**ONSITE SEWAGE DISPOSAL SYSTEM**

**REPAIR**

PROPERTY ADDRESS: 17105 Spring Hollow Court

The Baker Residence

## HOUSE LOCATION DRAWING

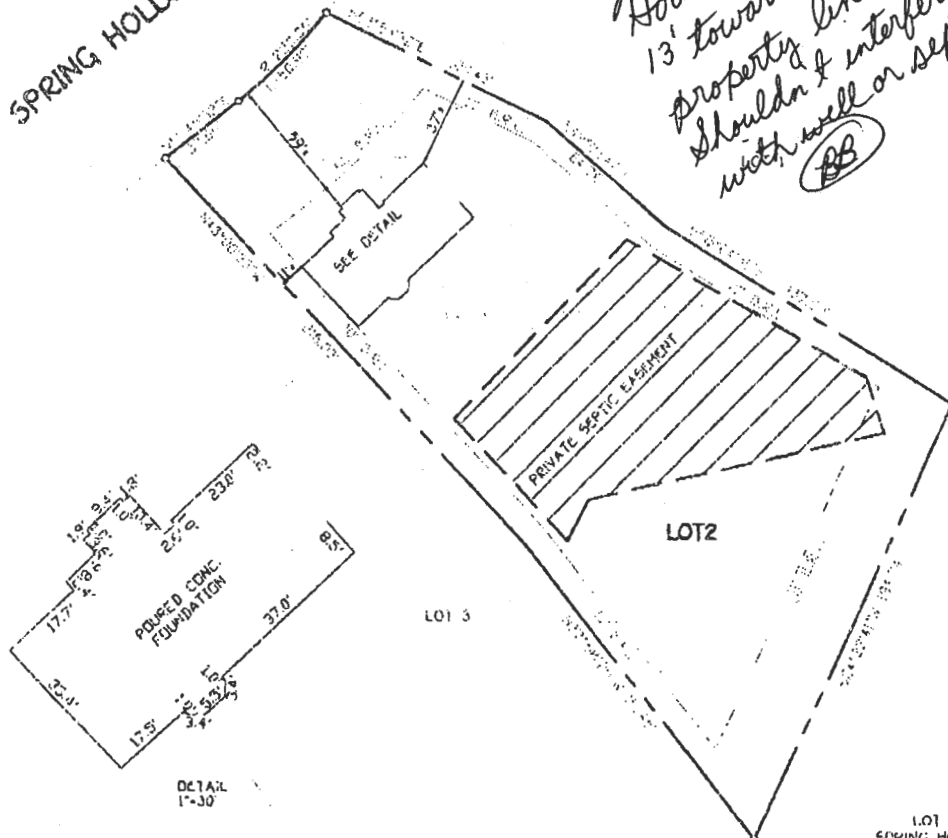
House moved  
13' toward right  
property line.  
Shouldn't interfere  
with well or septic.  
BB

**SITE PLAN**

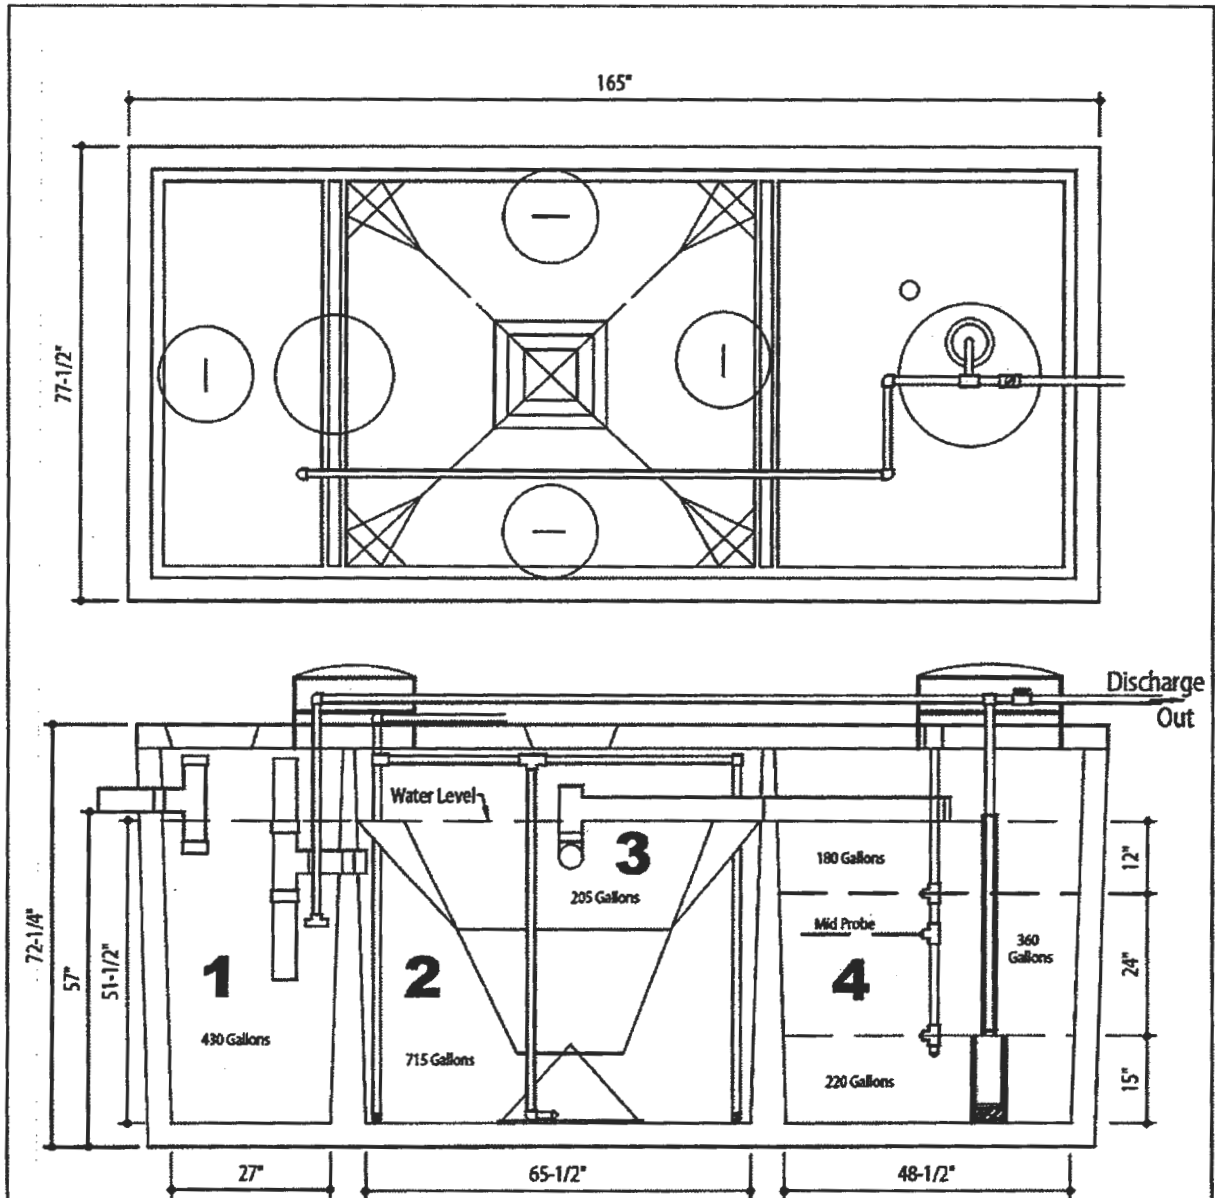
The existing system is currently sized for 4 bedrooms. The floor plan shows a total of 6 bedrooms. Before this office can approve the building permit, the septic system would have to be upgraded to a BAT unit sized for 6 BR's and a pump tank capable of handling 1 day of emergency storage. The existing trenches are sized properly for the proposed use but we will need to see how one replacement system will fit inside the existing sewage disposal area (SDA).

My phone is currently down. To receive BP approval by the Health Department, the septic tank and pump tank would have to be upgraded to a BAT unit designed for 6 bedrooms and pump tank capable of handling one day of emergency storage for a 6 bedroom house (Under current standards, septic systems are designed by # of bedrooms - COMAR 26.04.02). The existing trenches are large enough to accommodate 6 bedrooms so nothing has to be done with them. In addition to the tank and pump tank upgrades, we need to see how one replacement trench system will fit inside the existing sewage disposal area. This information would have to be outlined on a BAT Plan usually designed by an engineer for review and approval. Please see attached BAT Plan requirements. Also, a septic permit and inspection will also be required by this office for this upgrade. Should you have any questions, please don't hesitate to ask
